Engineering revision handoff

Engineering file ID 5.2 | SR1 builds on R6

5.2 SR1 adds mechanical switch retention following version 26's split-cage and removable-clamp principle. Version 26 itself is unchanged and was not requalified.

Walkie One 5.2 | SR1 mechanical switch capture

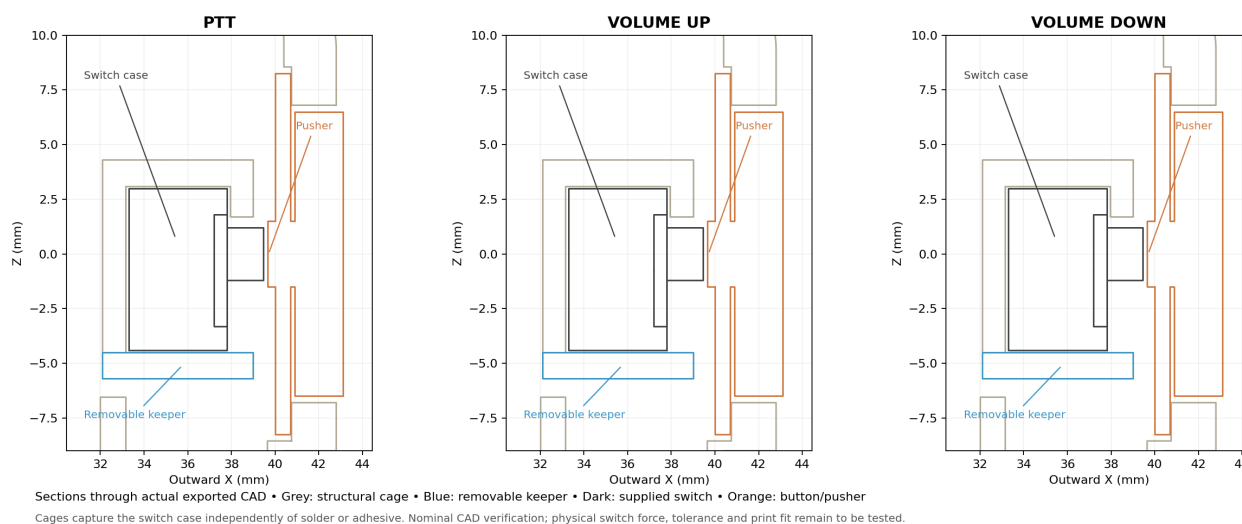
- Replaced three open bonded side-switch cradles with cages integrated into the front tub and removable screwed rear keepers.
- Added two front-switch corner retainers and a screwed cassette mounting, preserving calibrated seat and stop shims.
- Relieved the battery-tray ear and added rear-loading and screw-head access clearances.

Side-button gaps are nominally 0.14 mm, with modeled stops at 0.65 mm. Check actual switch limits and tolerances; these values do not certify allowable overtravel. See the front-switch sections in the package for the retained front interfaces.
